INSPECTION TICKET
INSPECTOR: IVR

ADDRESS . : NEIGHBORS RD SUBDIV:
CONTRACTOR : PHONE :
OWNER . . : POPE BRYON MARIS & REBECCA A PHONE : (910) 892-2353
PARCEL . . : 02-1528- - -0071- - -
APPL NUMBER: 06-50015272 CP NEW RESIDENTIAL (SFD)
DIRECTIONS : HWY 301 SOUTH FROM DUNN, TOWARDS BENSON
TURN LEFT ON NEIGHBORS RD AT CARLIE C'S
MCLAMBS OPERATIONS CENTER 3/4 MILE ON
RIGHT DJOHNSON

STRUCTURE: 000 000 75X37.5 3 BR
FLOOD ZONE : FLOOD ZONE X

Job	Truss	Truss Type	Qty	Ply	Bryan Pope/Dunn NC	1 UNIT YF	H0998033
13308	HGR01	PIGGYBACK ATTIC	2	3	Job Reference (optional)

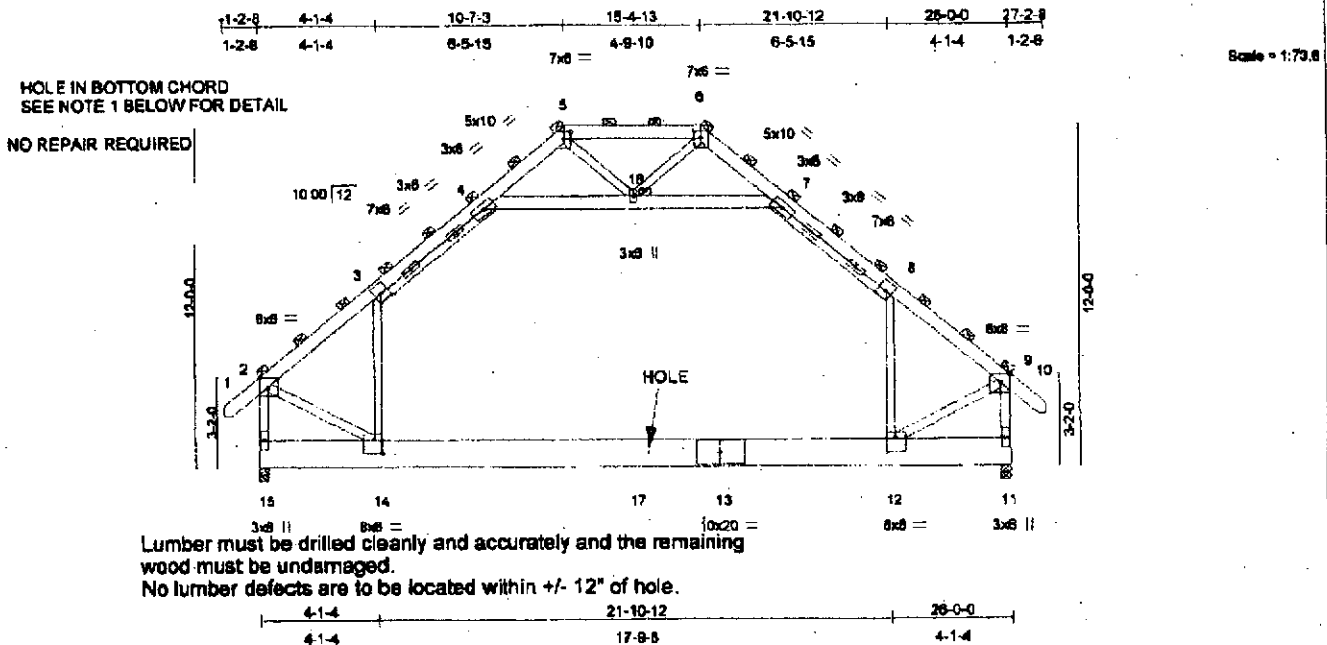
- 1) Repair Condition: 0-0-12 dia. hole located 0-5-10 from the bottom edge to the center of hole in bottom chord 2-8-4 to the left of joint 13.
- 2) N/A

1. Garage truss repairs not done in accordance with instructions. nails shall be on both sides and clinched Do NOT over nail
			2. Provide engineers letter stating excessive nail pattern usded to secure girder trussed did not damage parent material.

1. Garage truss repairs not done in accordance with instructions. nails shall be on both sides and clinched! Do NOT over nail

2. Provide engineers letter stating excessive nail pattern used to secure girder trussed did not damage parent material.

C & R Building Supply's truss designer, David Williams went out to the Bryan Pope job on Neighbors Rd. to inspect the truss. There was nothing found wrong with the truss that would cause a component failure.
